May 31, 2007

Re: Mitigation Order on Consent No. P-50-06, Response to Comments on Identification of Potential Interim Actions, Groundwater Monitoring Report, Well Inventory Report

This letter is submitted in response to Arizona Department of Environmental Quality's (ADEQ) comment letter to Phelps Dodge Sierrita, Inc. (PDSI) dated March 12, 2007, on the Identification of Potential Interim Actions, Groundwater Monitoring Report, and Well Inventory Report submitted during December 2006.

FLOW CHART ILLUSTRATING INTERIM ACTION EVALUATION AND IMPLEMENTATION ACTIONS FOR EACH

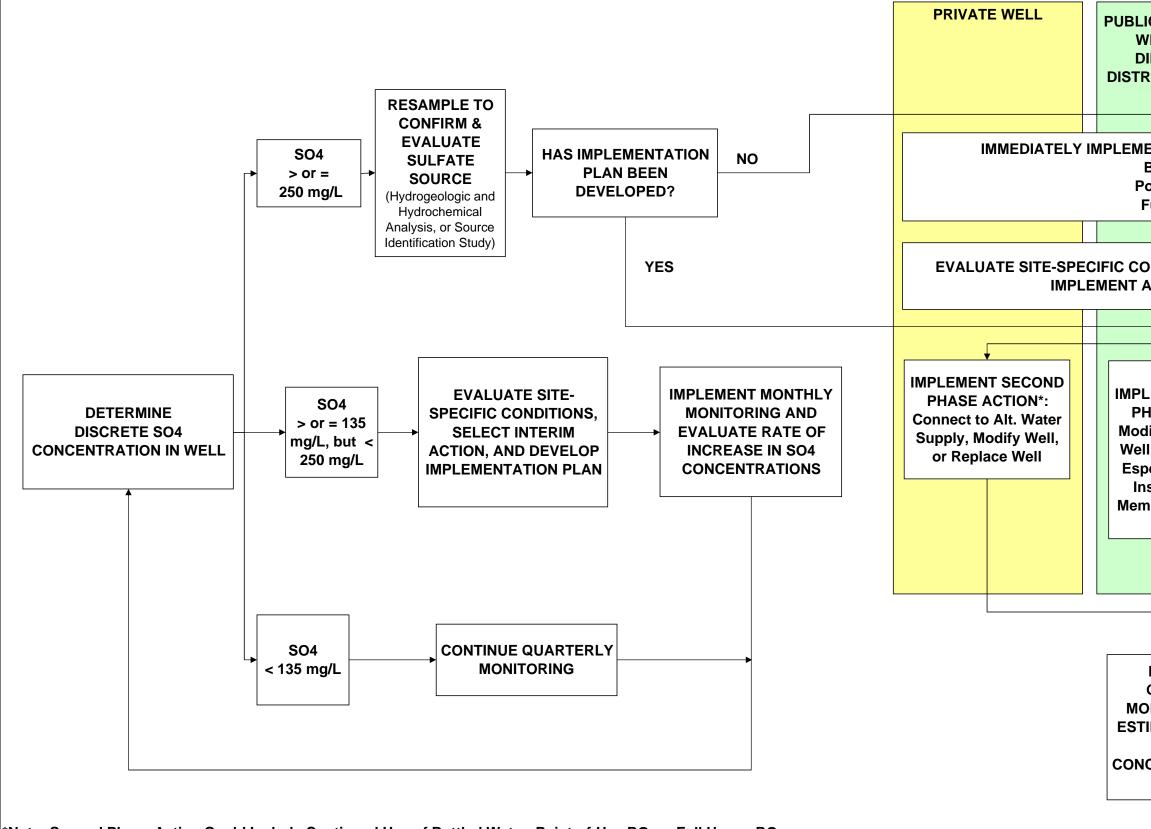
The report identifies 10 drinking water wells that could potentially require future interim mitigation actions. Further, during the March 6, 2007 meeting, PDSI stated that because most of these drinking water wells are located in the middle towards the southern portion of the well field area, the likelihood of sulfate concentrations exceeding 250 mg/l at such wells is remote. Nevertheless, there are three or four drinking water wells located in northern portion of the well field area that are susceptible to high sulfate impacts. Given the availability of information, PDSI should provide more than a glimpse of how it will respond and implement interim actions to mitigate sulfate impact at drinking water supplies that exceed 250 mg/l. At a minimum, ADEQ recommends PDSI provides a flow chart describing

specific actions that will be taken, should sulfate concentration exceed 250 mg/l under any of the following three hypothetical scenarios presented in the report:

- 1. A private well (only one private well is identified on the list);
- 2. A public water supply well feeding directly into the distribution system (Any of the 6 wells in this category can be used); and
- 3. A public drinking water supply that is blended with other wells (ESP-1 is a good example).

Attached is a flow chart that illustrates the actions that PDSI would take depending upon the discrete sulfate concentration that is detected in each type of water supply well. If the sulfate concentration is less than 135 mg/L, PDSI will continue quarterly monitoring. If the sulfate concentration is greater than or equal to 135 mg/L, but less than 250 mg/L, PDSI will conduct an evaluation of site-specific conditions for the well, select an interim action, and develop an implementation plan for the selected action. PDSI will also begin monthly sampling of the well and evaluate the rate of increase in sulfate concentrations for purposes of determining when the selected interim action may need to be implemented. If the sulfate concentration exceeds 250 mg/L, PDSI would resample the well to confirm the initial sample result and determine whether the Phelps Dodge Sierrita Tailings Impoundment (PDSTI) is or is not the source. These actions would be followed by the immediate implementation of the selected interim action identified in the implementation plan prepared while sulfate concentrations are between 135 and 250 mg/L. As the flow chart indicates, the specific action that would be implemented depends upon the well type (e.g., private well versus public water supply well, and whether water from a public supply well is blended with water from other wells). Under the highly unlikely situation that sulfate concentration in a well suddenly exceeds 250 mg/L and an implementation plan has not been prepared, PDSI would immediately implement a first phase interim action, such as bottled water, point-of-use reverse osmosis (RO) treatment, or full house RO treatment. The first phase action would be followed by an evaluation of site-specific conditions and determination of whether to continue the first phase action or implement a second phase action until the Mitigation Plan is completed. In all cases, the implementation of an interim action would be followed by quarterly monitoring of sulfate concentrations for purposes of determining the "average" sulfate concentration, the parameter that would trigger cessation of the interim action.
